# Aguilar Subdivision Unit 1

City of El Paso — City Plan Commission — 12/6/2018

**SUSU18 - 00064 — Major Combination**

### PROPOSED (Pellicano)

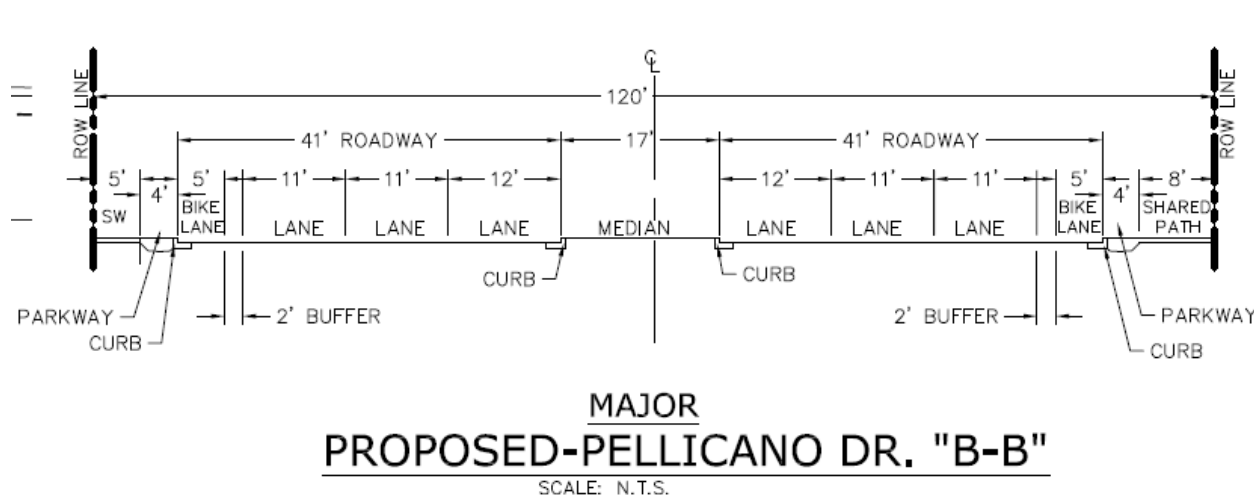
El Paso County will be constructing improvements to Pellicano above and beyond what would be required per the City's DSC. These improvements include 41' of roadway, a 5' bike lane, including a 2' buffer between the bike lane and the driving lanes, as well as a 5' sidewalk, and a 4' parkway. The proposed 4' parkway is 1' narrower than what is required and is the basis for the waiver request.

### REQUIRED (Joe Battle)

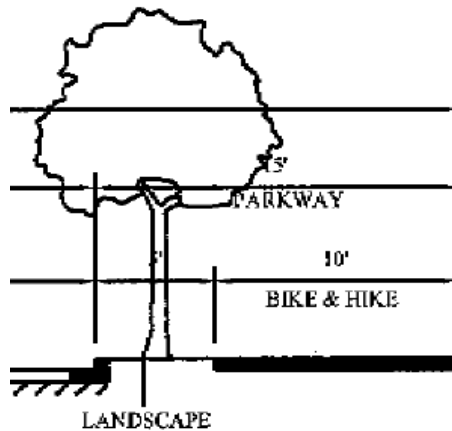
Joe Battle is classified as a freeway, while the City does not have jurisdiction over a freeway, the City does have purview over parkway improvements with concurrence from TxDOT. The City's bike plan calls for a 15' parkway to include a 5' landscape buffer and a 10' hike and bike.

### PROPOSED (Joe Battle)

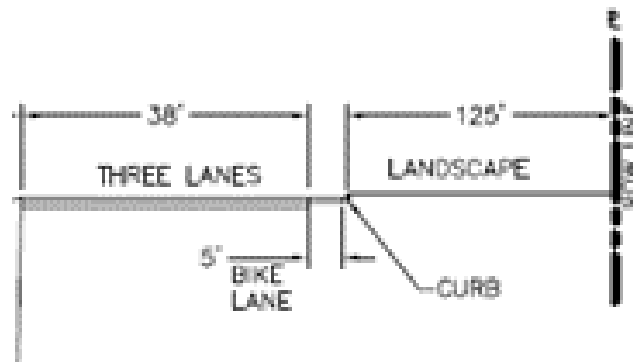
The applicant proposes to follow TxDOT requirements, which will only require a 5' sidewalk. However, the applicant is waiting on TxDOT's determination of whether or not a deceleration lane will be required before updating the cross-section to include a sidewalk. It should be noted that there is an existing 5' bike lane along Joe Battle.

Staff is still waiting for TxDOT to comment on the applicant's waiver request to waive the required parkway improvements along Joe Battle.

## PRELIMINARY PLAT

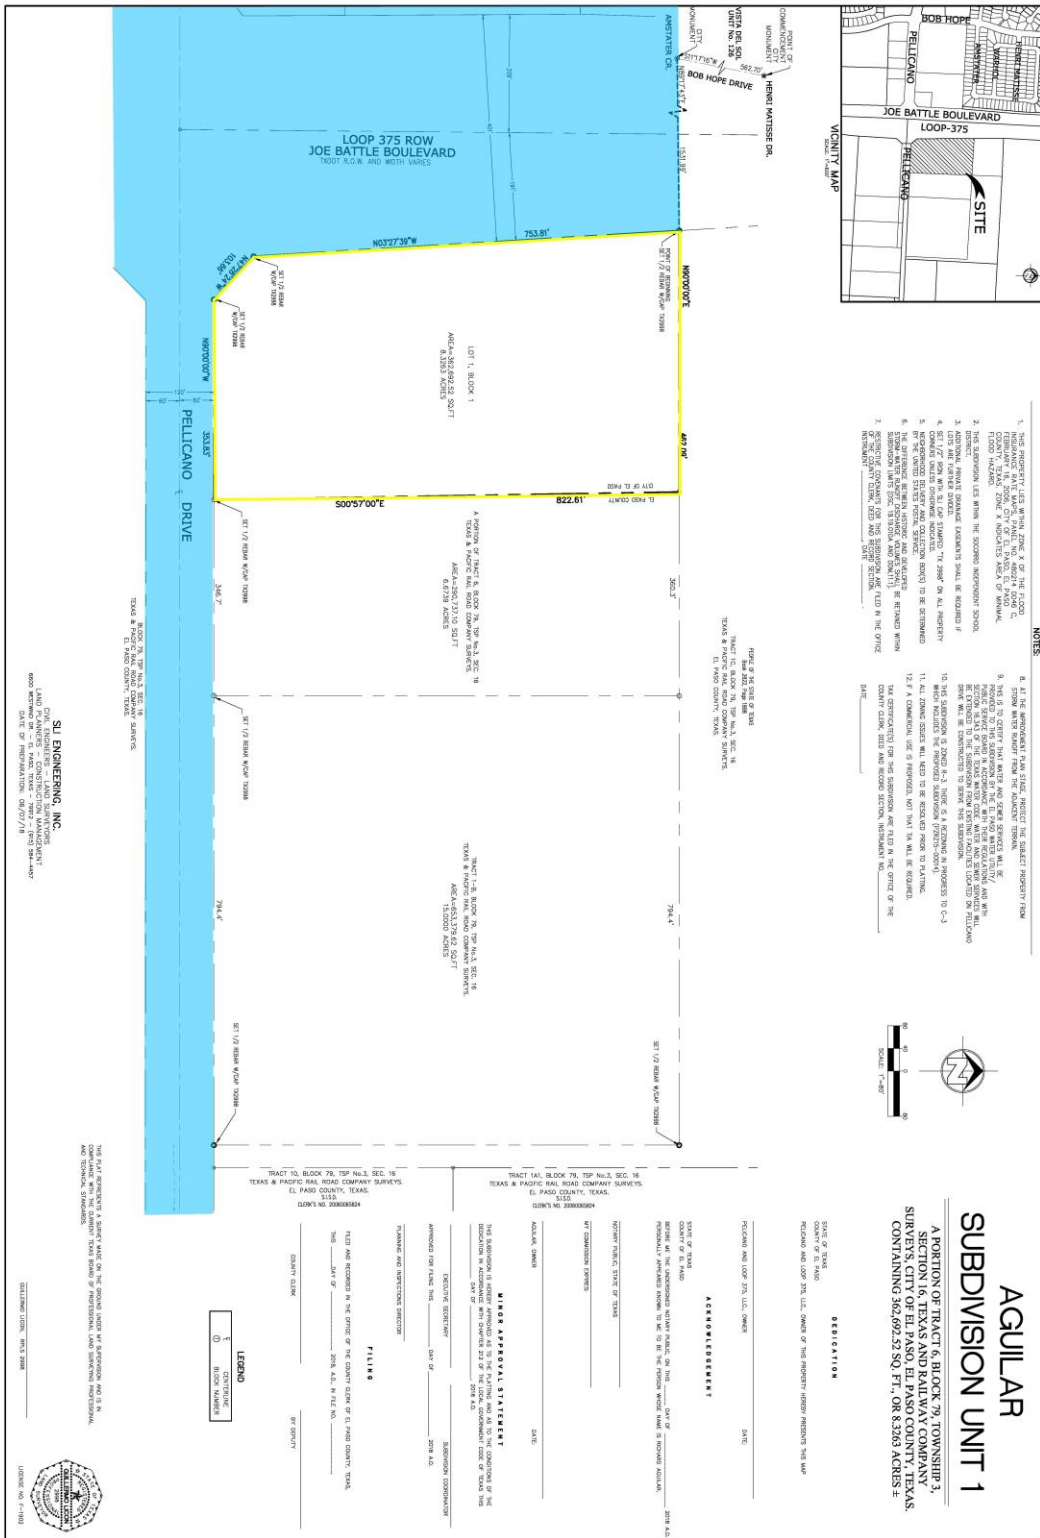
2. Show existing and proposed drainage flow patterns on the preliminary plat.

3. On the Preliminary Plat, show and label the proposed pond location within the lot. Any proposed ponding area shall have enough capacity to hold the developed runoff for a designed 100-yr. storm event.
